TECHNICAL EVALUATION REPORT
**RADIOLOGICAL EFFLUENT TECHNICAL
SPECIFICATION IMPLEMENTATION (A-2)**
NORTHEAST NUCLEAR ENERGY COMPANY
MILLSTONE POINT NUCLEAR POWER STATION UNIT 2

NRC DOCKET NO. 50-336

FRC PROJECT C5506

Figure 1. Liquid Effluent Release Paths, Millstone Unit 2

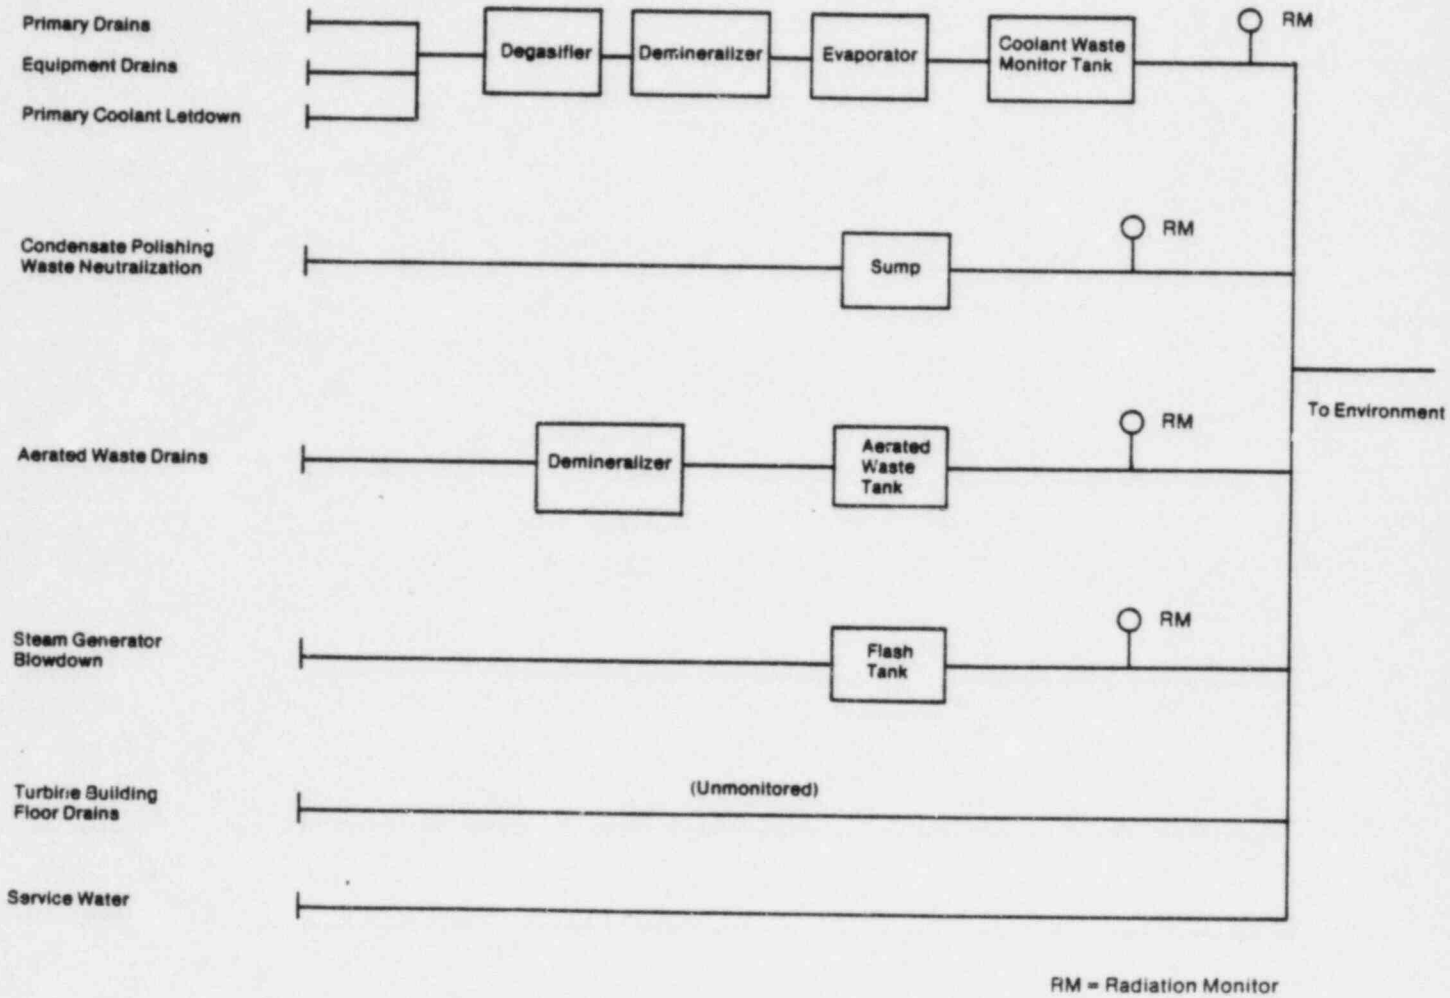
A diagram of the liquid radwaste system showing the location of the liquid effluent monitors is shown in Figure 1. The processed liquid radwaste originating from the primary and equipment drain tanks is monitored by the clean liquid radwaste effluent line monitor. The steam generator blowdown and condensate polishing waste effluents are monitored by the steam generator blowdown monitor and the condensate polishing facility waste neutralizing sump discharge line monitor, respectively. The processed liquid waste that originates at the aerated waste drain tank is monitored by the aerated liquid radwaste effluent line monitor. These monitors are all provided with automatic termination of release upon a high-concentration alarm signal.

building sump effluent line are adequately sampled, but continuous composite samplers are not provided. There are no liquid radwaste holdup tanks outside plant buildings that require tank level indicating devices. Figure 1 shows the location of the liquid effluent radiation monitors.

Figure 2. Gaseous Effluent Release Paths, Millstone Unit 2

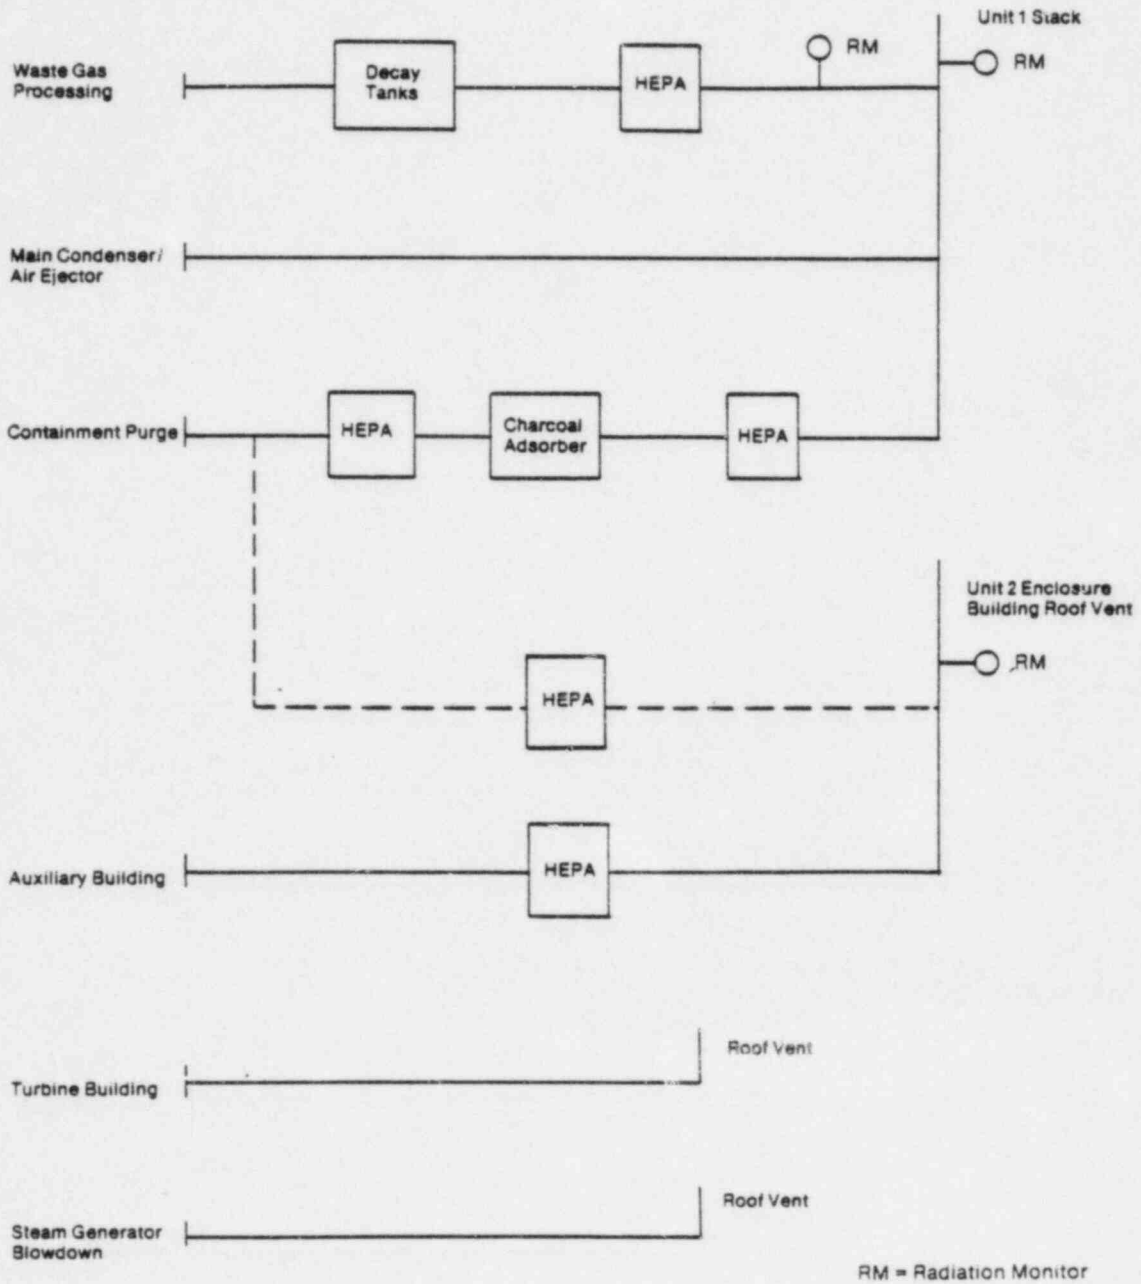
A diagram showing the location of radioactive gaseous effluent monitors is shown in Figure 2. Wastes originating from the following sources are discharged through the Unit 1 stack and monitored by the Unit 1 main stack monitor: main condenser/air ejector, containment purge, and waste gas processing system. The waste gas processing system is equipped with a process noble gas radiation monitor and an oxygen monitor to detect the presence of an explosive gas mixture. The turbine building ventilation exhaust and the steam generator blowdown tank vent are normally released without monitoring. Figure 2 also shows the location of HEPA filter and charcoal adsorber units.

In Section 3/4.3.3.10 of the Licensee's submittal, a commitment is made to monitor and control all significant gaseous effluent release paths. The following monitors are provided for this purpose: MP2 stack monitor, MP1 main stack monitor, and the waste gas holdup system noble gas monitor. These monitors are demonstrated to be operable by performance of surveillance operations consistent with the model RETS [1]. Figure 2 shows the location of the gaseous effluent radiation monitors and the substreams monitored by each.
